PIC16(L)F1934/1936/1937 Family Silicon Errata and Data Sheet Clarification

The PIC16(L)F1934/1936/1937 family devices that you have received conform functionally to the current Device Data Sheet (DS41364E), except for the anomalies described in this document.

The following typographic corrections and clarifications are to be noted for the latest version of the device data sheet (DS41364E):

FIGURE 1: INSTRUCTION CYCLE DELAY CALCULATION EXAMPLE

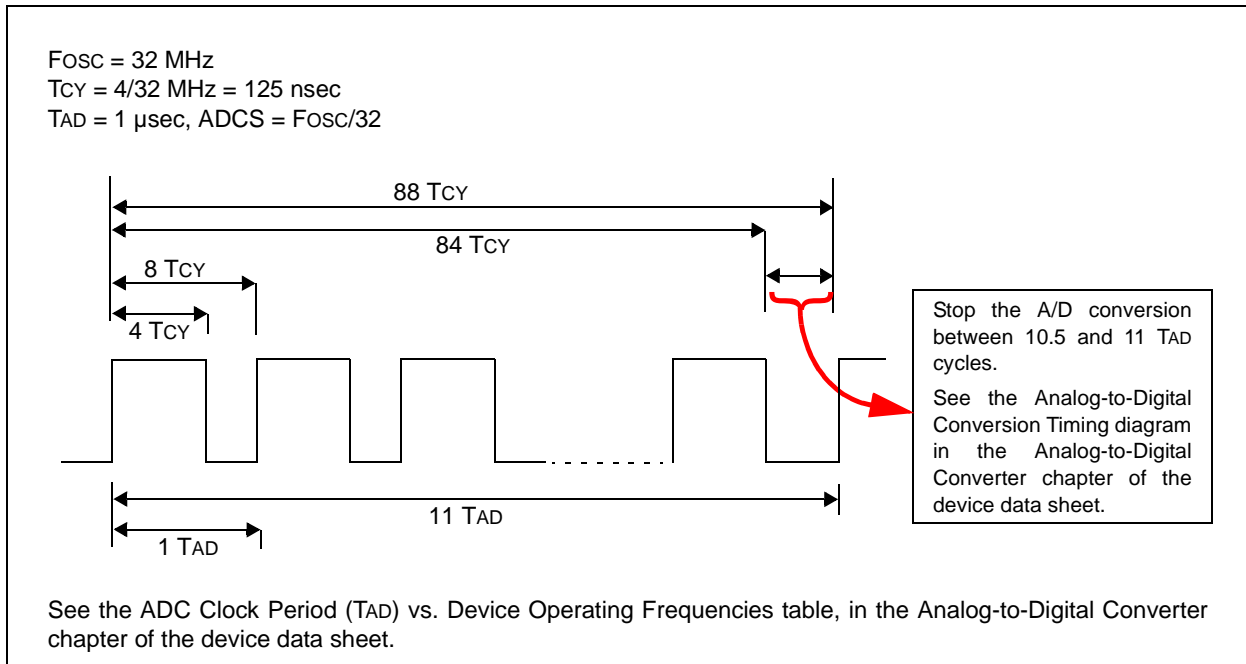
An ADC conversion may not complete under these conditions:

1. When FOSC is greater than 8 MHz and it is the clock source used for the ADC converter.
2. The ADC is operating from its dedicated internal FRC oscillator and the device is not in Sleep mode (any FOSC frequency).

When this occurs, the ADC Interrupt Flag (ADIF) does not get set, the GO/DONE bit does not get cleared, and the conversion result does not get loaded into the ADRESH and ADRESL result registers.

Method 3: This method is provided if the application cannot use Sleep mode and requires continuous operation at frequencies above 8 MHz. This method requires early termination of an ADC conversion. Provide a fixed time delay in software to stop the A-to-D conversion manually, after all 10 bits are converted, but before the conversion would complete automatically. The conversion is stopped by clearing the GO/DONE bit in software. The GO/DONE bit must be cleared during the last 1/2 TAD cycle, before the conversion would have completed automatically. Refer to [Figure 1](#) for details.

In [Figure 1](#), 88 instruction cycles (TCY) will be required to complete the full conversion. Each TAD cycle consists of 8 TCY periods. A fixed delay is

provided to stop the A/D conversion after 86 instruction cycles and terminate the conversion at the correct time as shown in the figure above.

Note: The exact delay time will depend on the TAD divisor (ADCS) selection. The Tcy counts shown in the timing diagram above apply to this example only. Refer to [Table 3](#) for the required delay counts for other configurations.
